ADDENDUM NO. 1 TO PROJECT NO. 47261

CONSTRUCTION WORK PROVIDE MASONRY REPAIRS, FAÇADE, BUILDING 40 CREEDMOOR PSYCHIATRIC CENTER 80-45 WINCHESTER BOULEVARD QUEENS VILLAGE, NY

January 9, 2026

DRAWING NUMBER:
A-585

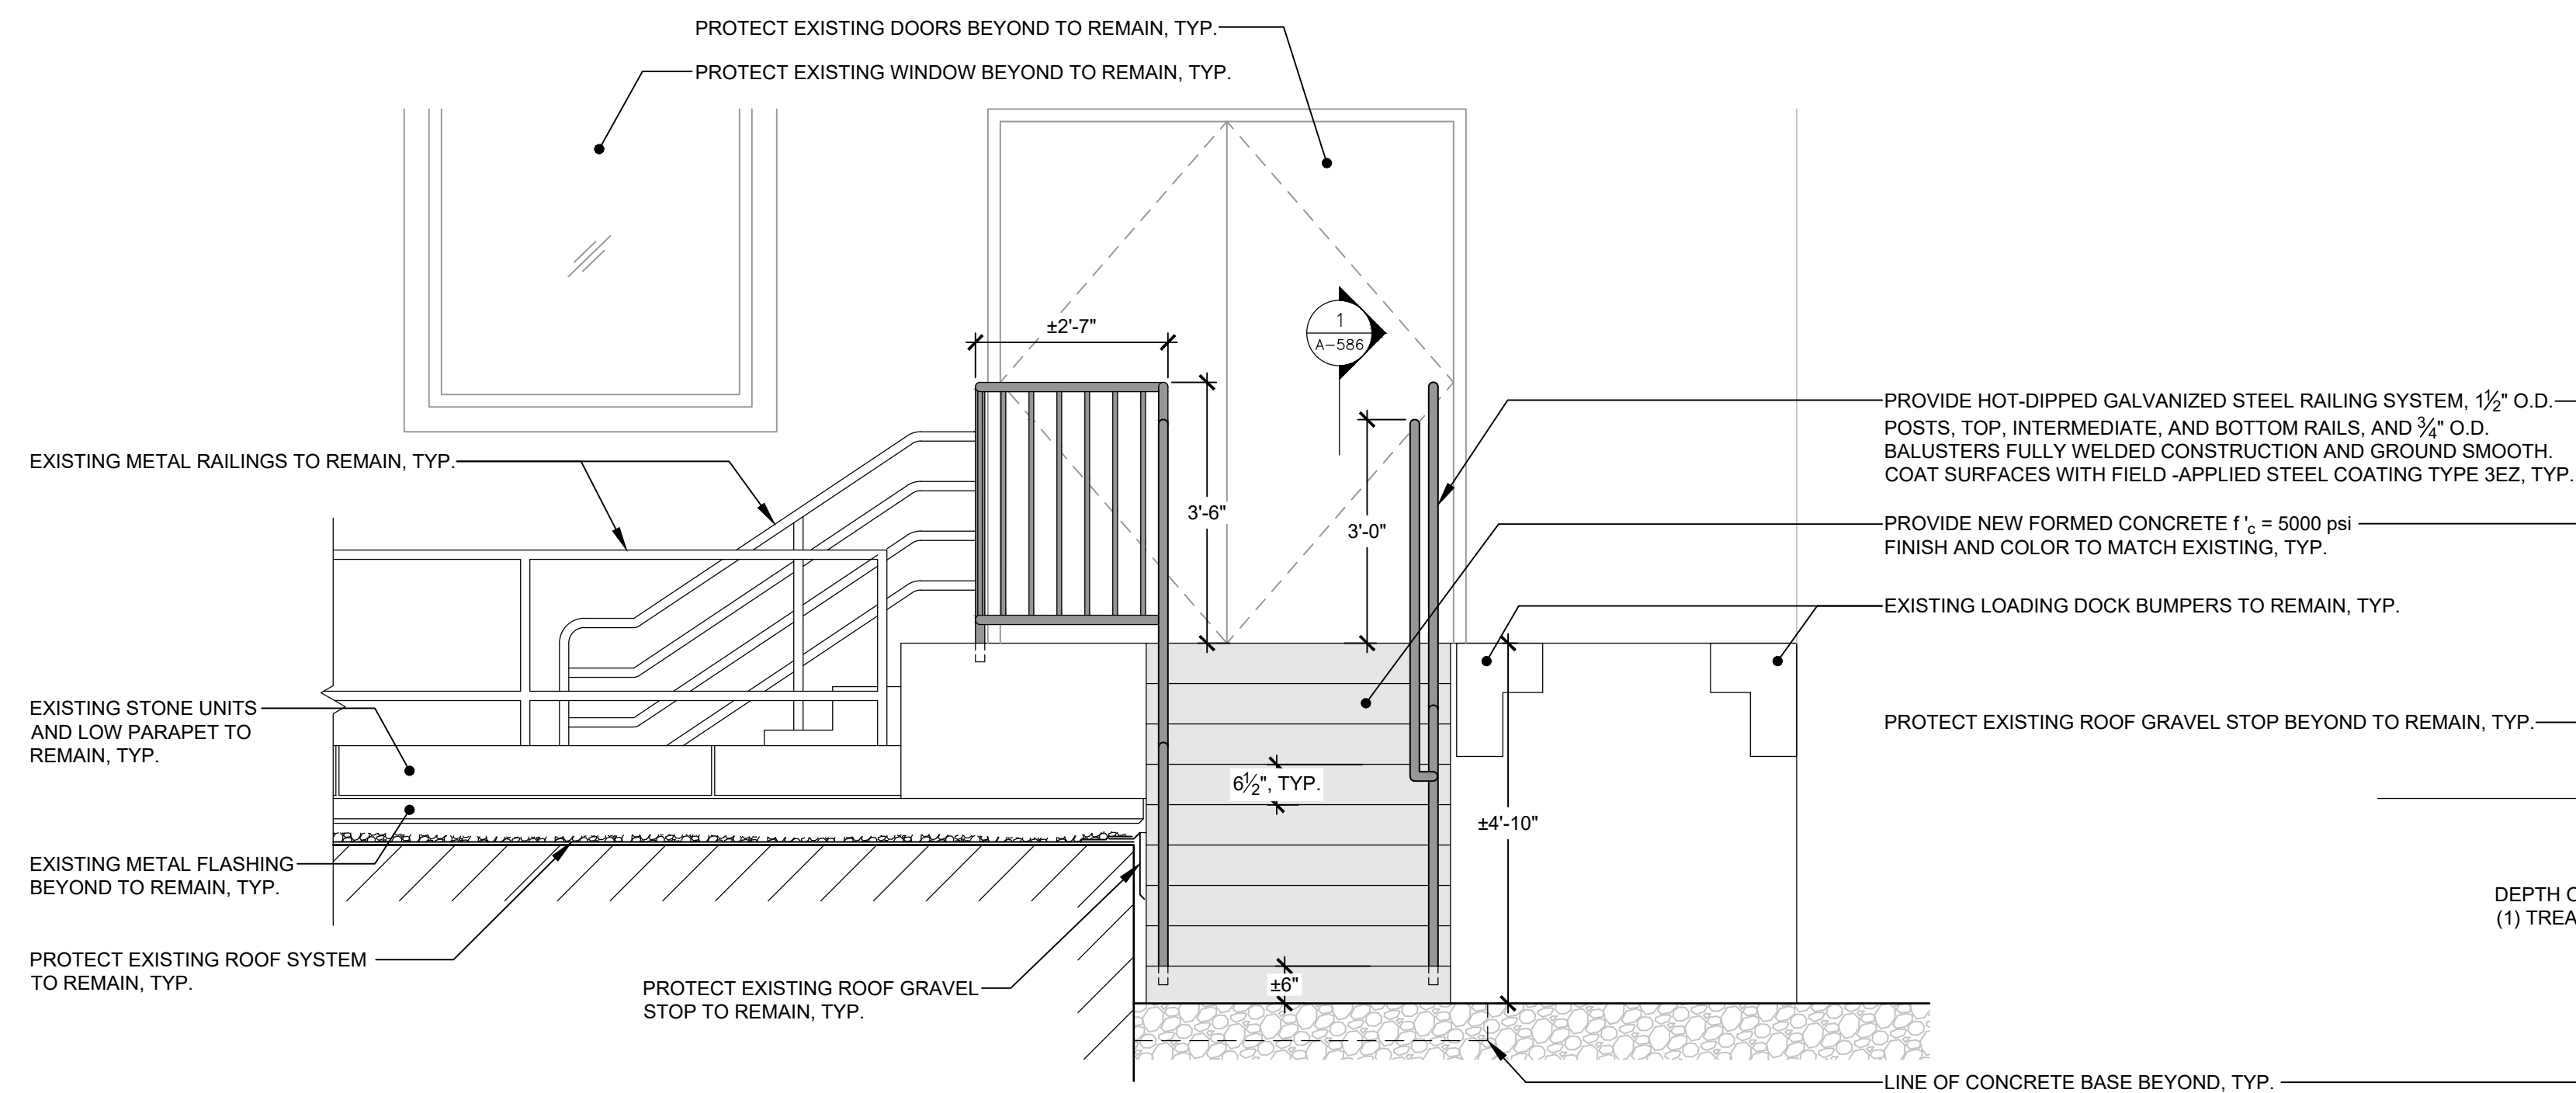
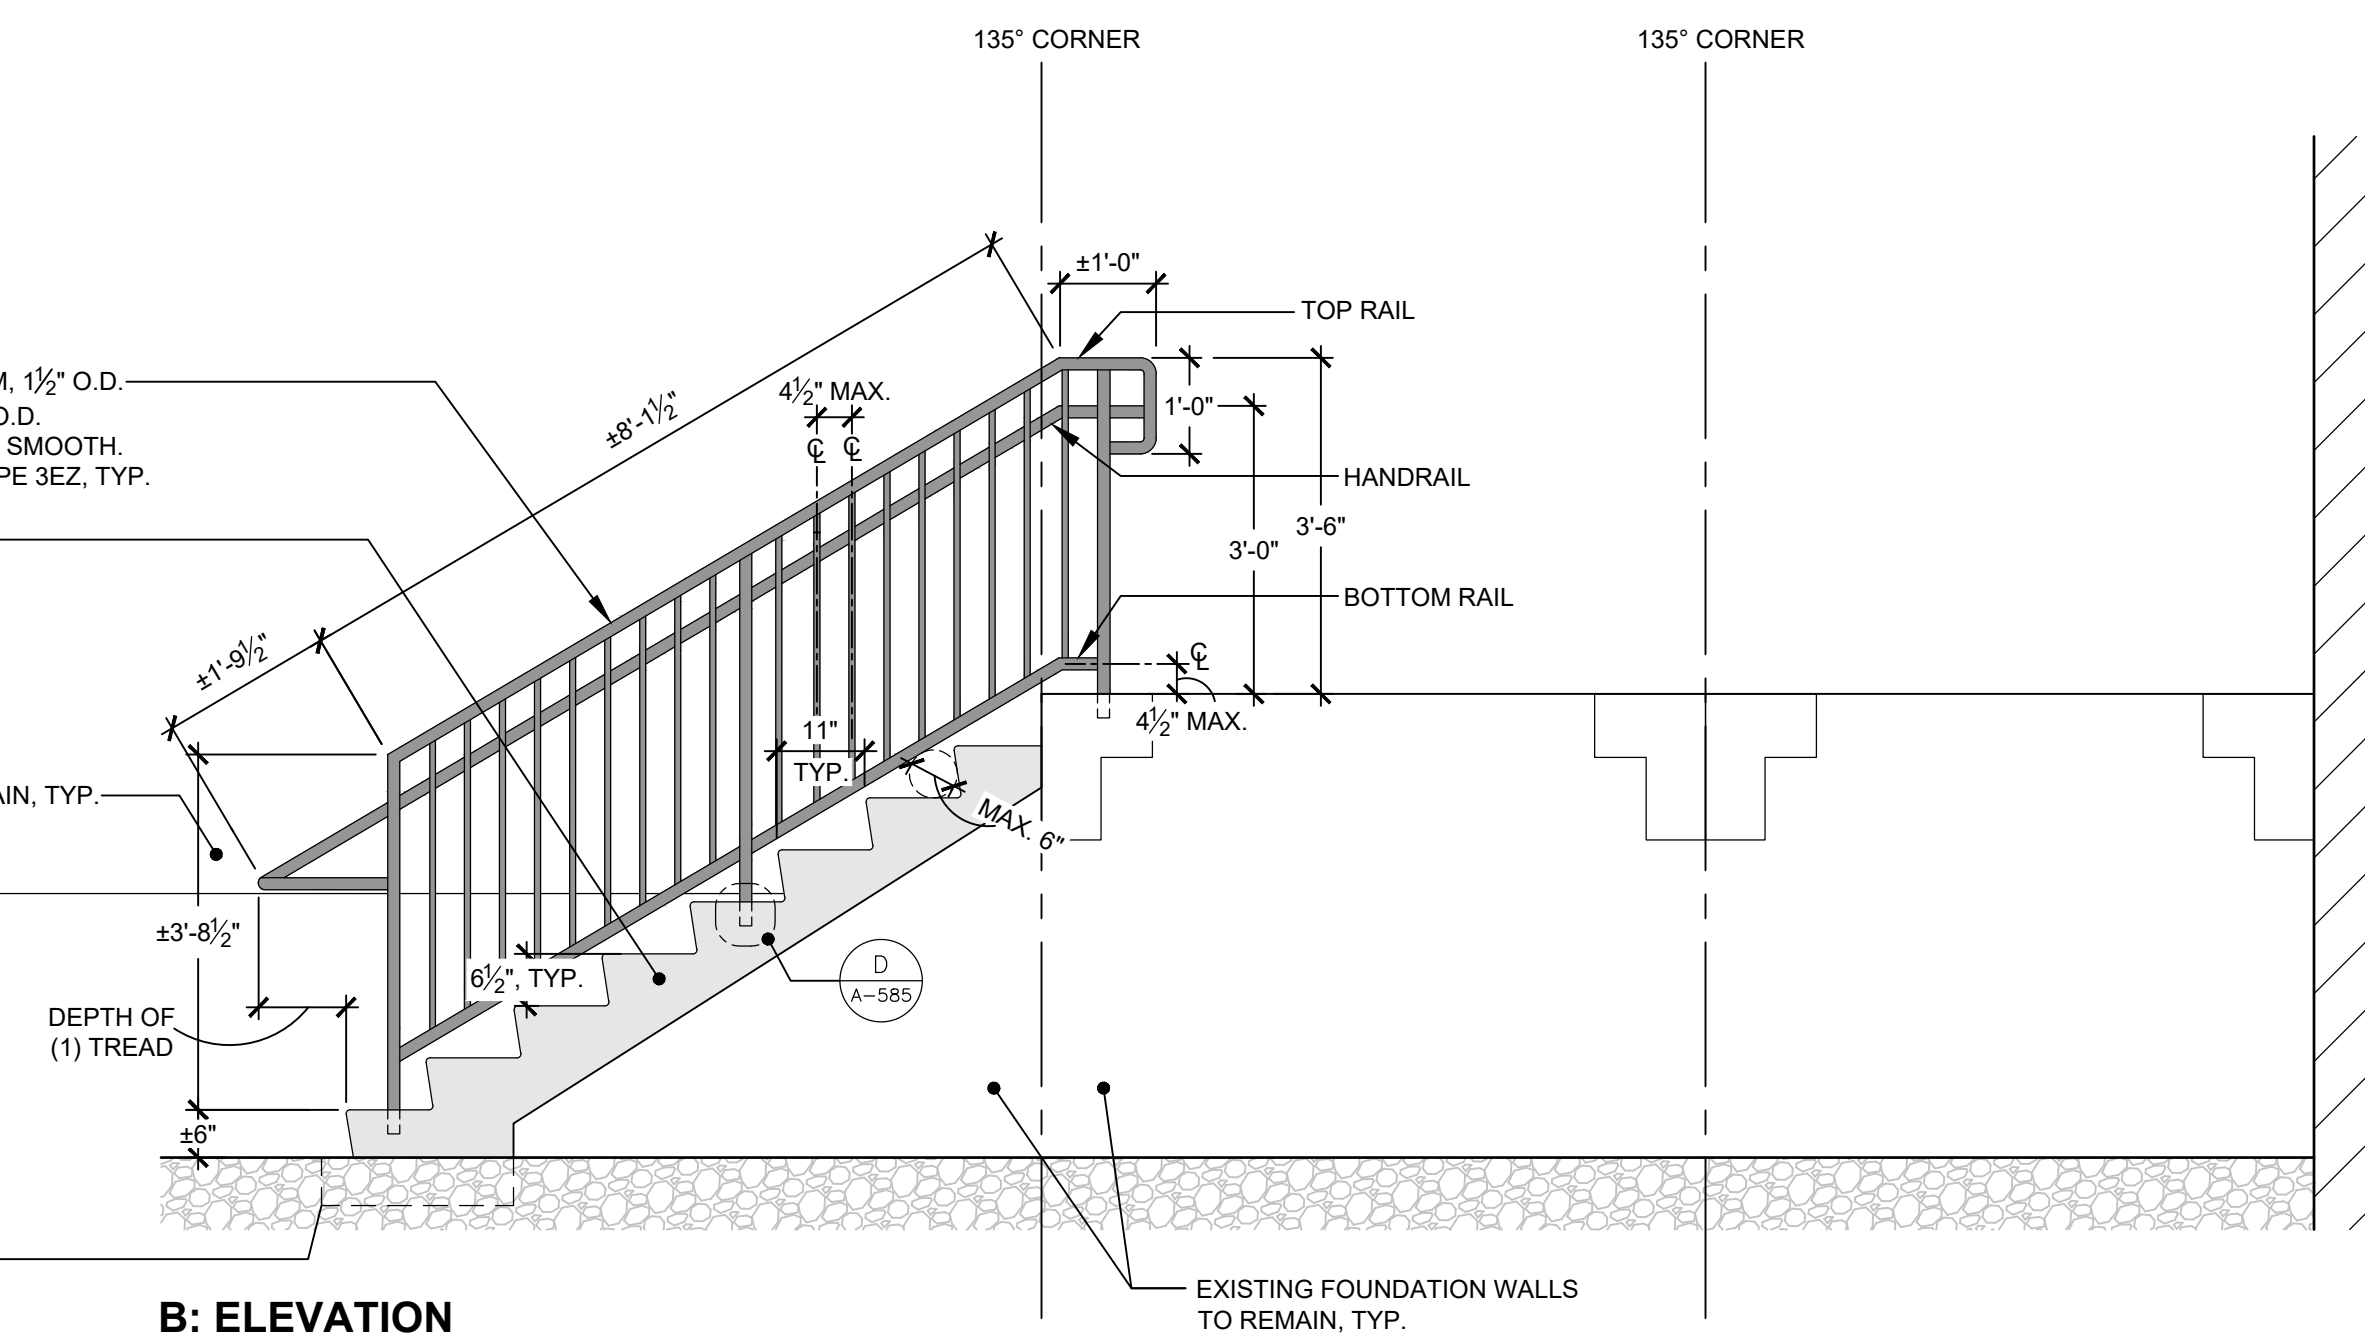
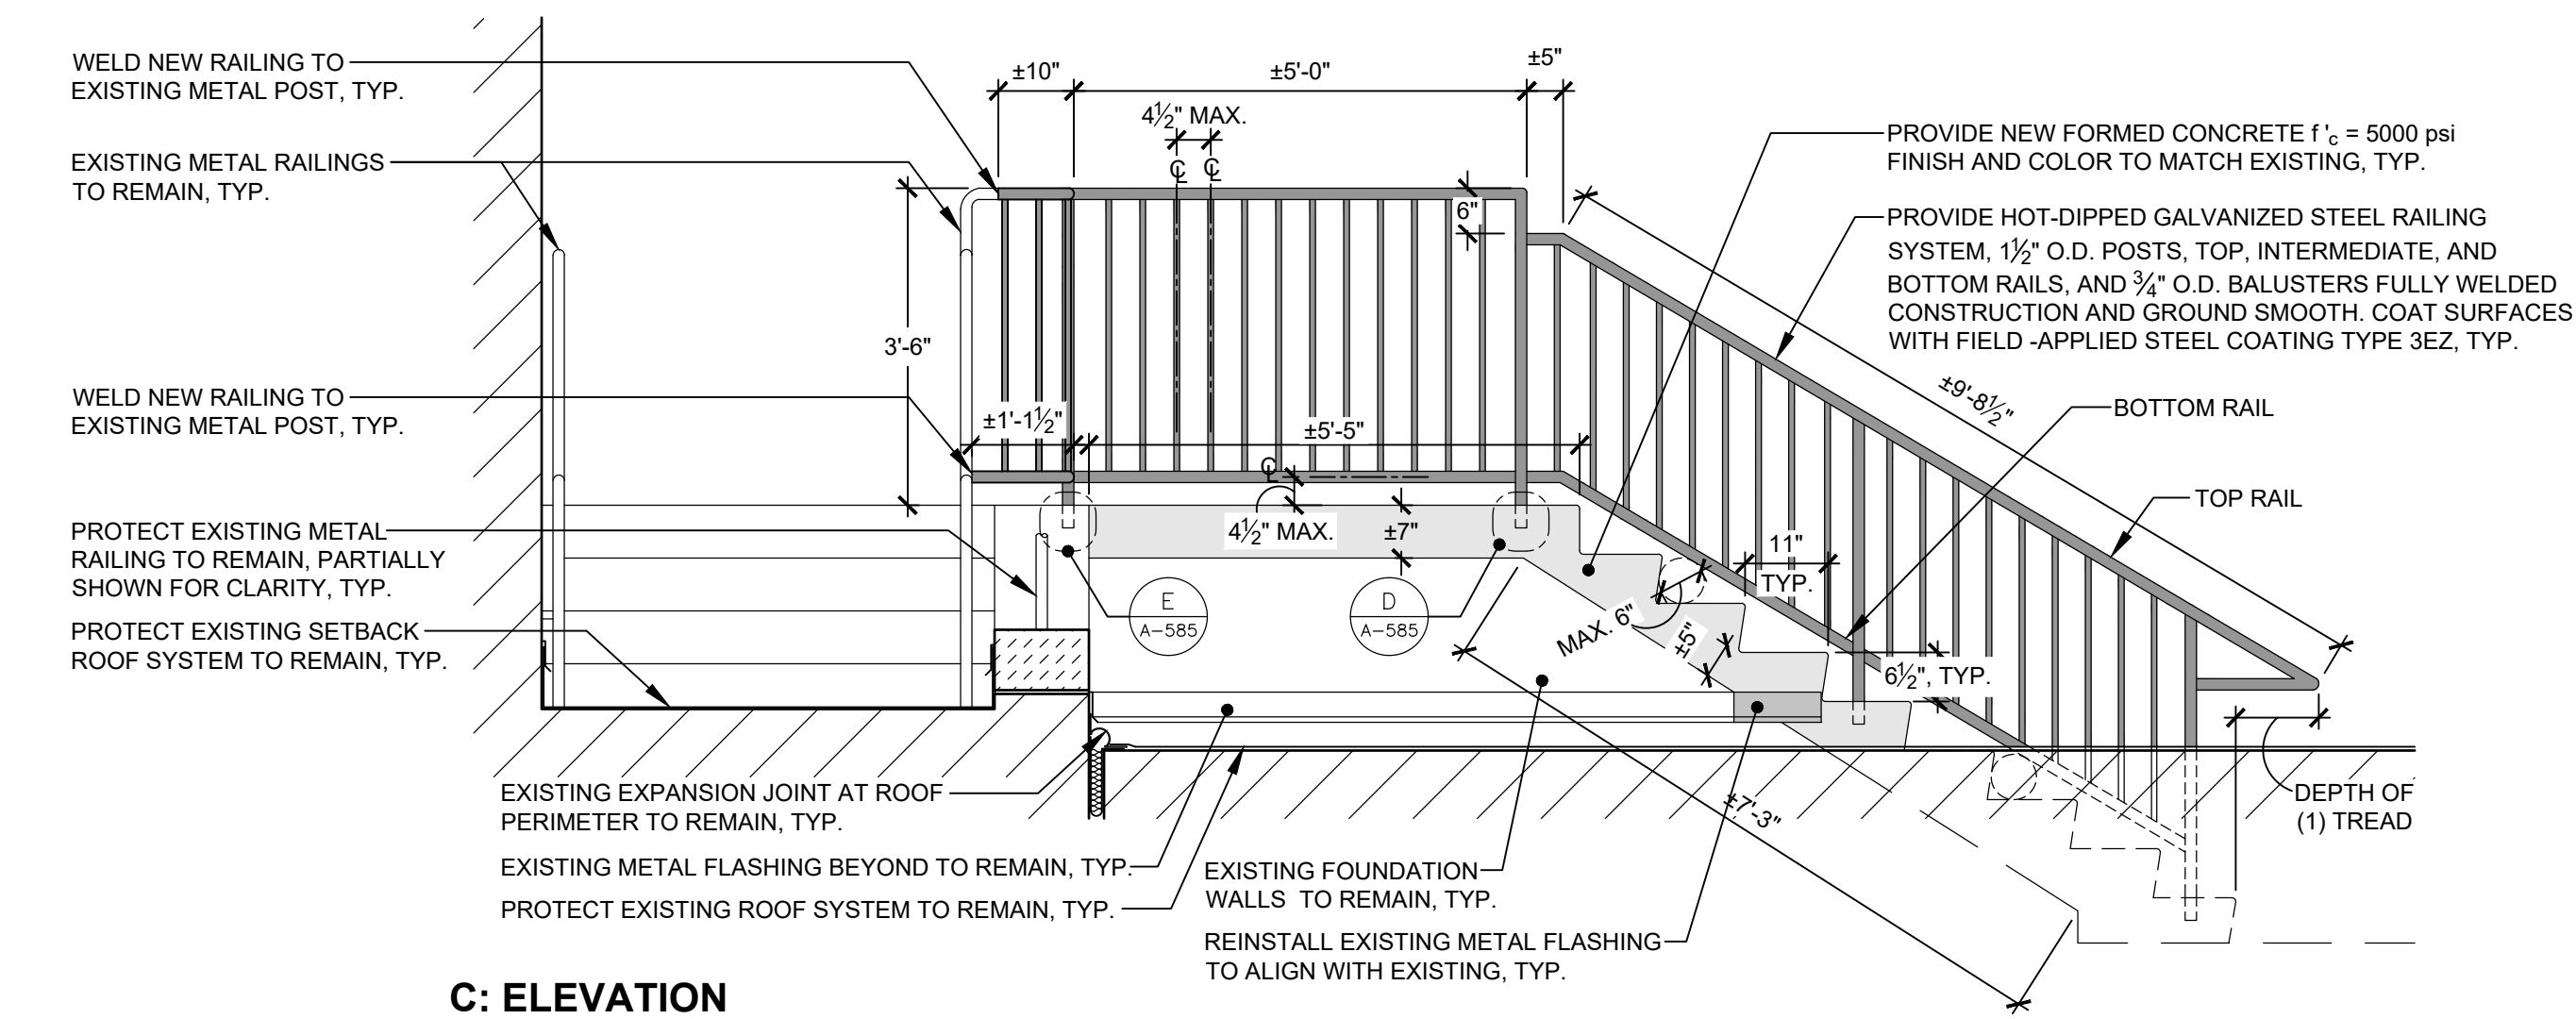
8. Drawing No. A-546
 - a. Included note of location of traffic coating application.
9. Drawing No. A-568
 - a. Included note of location of traffic coating application.
10. Drawing No. A-574
 - a. Included note of location of traffic coating application.
11. Drawing No. A-585
 - a. Included note of location of traffic coating application.
12. Drawing No. A-588
 - a. Included note of location of traffic coating application.
13. Drawing No. A-590
 - a. Included note of location of traffic coating application.
14. Drawing No. A-592
 - a. Included note of location of traffic coating application.
